**PERMIT INFORMATION**

<b>Permit Number:</b> C-1996-084 <b>Mine Name:</b> Lorencito Canyon Mine <b>Operator:</b> New Elk Coal Company, LLC <b>Operator Address:</b> Mr. Louis Head 12250 Highway 12 Weston, CO 81091	<b>County:</b> Las Animas <b>Operation Type:</b> Surface <b>Permit Status:</b> Permanent Cessation <b>Ownership:</b> Private
	<b>Operator Representative Present:</b>  None
<b>Operator Representative Signature: (Field Issuance Only)</b>

**INSPECTION INFORMATION**

<b>Inspection Start Date:</b> February 26, 2018 <b>Inspection Start Time:</b> 10:45 <b>Inspection End Date:</b> <b>Inspection End Time:</b>		<b>Inspection Type:</b> Aerial Inspection <b>Inspection Reason:</b> Normal I&E Program <b>Weather:</b> Clear	
<b>Joint Inspection Agency:</b>  None		<b>Joint Inspection Contacts:</b>  	
<b>Post Inspection Agency:</b>  None		<b>Post Inspection Contacts:</b>  	
<b>Inspector(s):</b>  Harry B. Ranney	<b>Inspector's Signature:</b>  		<b>Signature Date:</b>  3/1/2018

**Pond 8 on left side of photo. Fill 8 in upper right.**

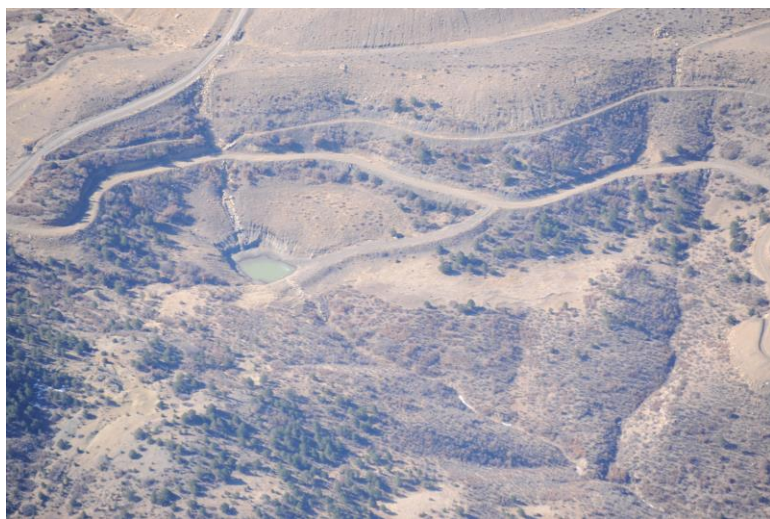
No large rills or other problems were identified with Fills 7, 8, or 9.

Ponds 6, 7, 8, 9, and 9A were inspected, and all contained water. No issues were identified with embankments or spillways.
